**SAN ANTONIO WATER SYSTEM  
Interdepartment Correspondence Sheet**

**Subject:** Zoning Case Z2019-10700337 (Stone Oak 13.330-Acres MF)

**Date:** April 28, 2020

**Figure 3**  
**Conceptual site plan w/sensitive feature buffer**

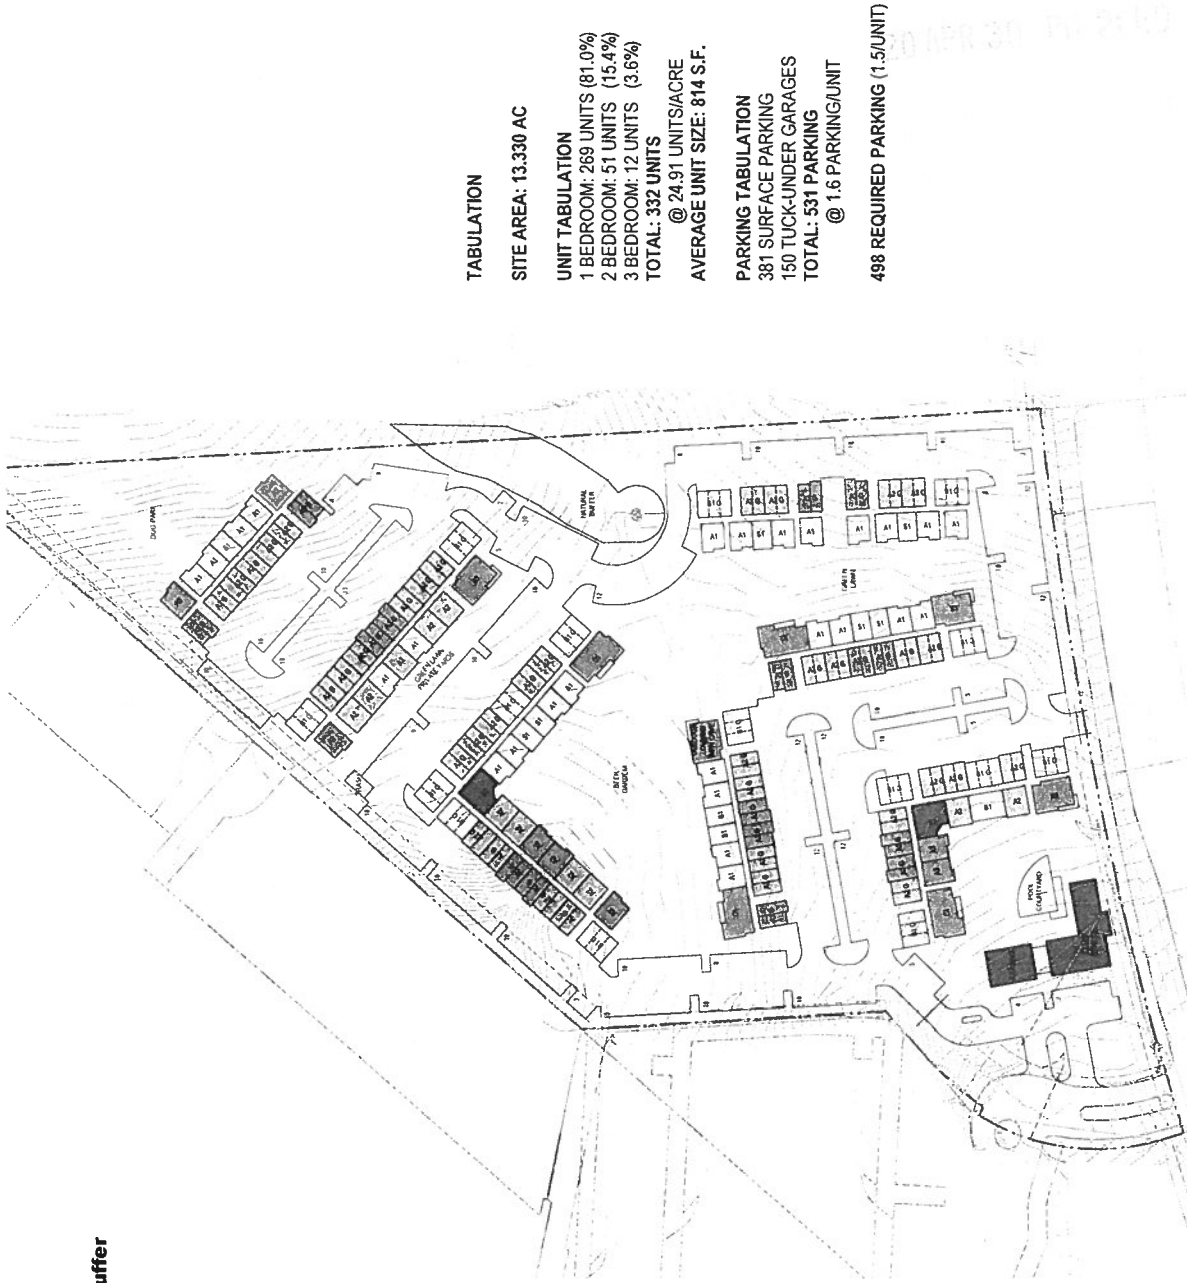
1. A sensitive geologic feature located along the northeast quadrant of the property, has the potential for contamination of the Edwards Aquifer.

1. The impervious cover shall not exceed 65% on the 13.330-acre site.
2. A natural buffer shall be provided for the sensitive geologic feature located on-site, consisting of a variable width buffer extending north-easterly on the up-gradient slope and extending south with an earthen berm on the down-gradient slope. The natural buffer shall be protected within a fenced 13,476-square foot enclosure. The location of the natural buffer is further shown in the submitted conceptual site plan, attached as Figure 3. The intent of this exhibit is to show the location and buffering of the sensitive geologic feature, however, the remainder of the site is subject to change.
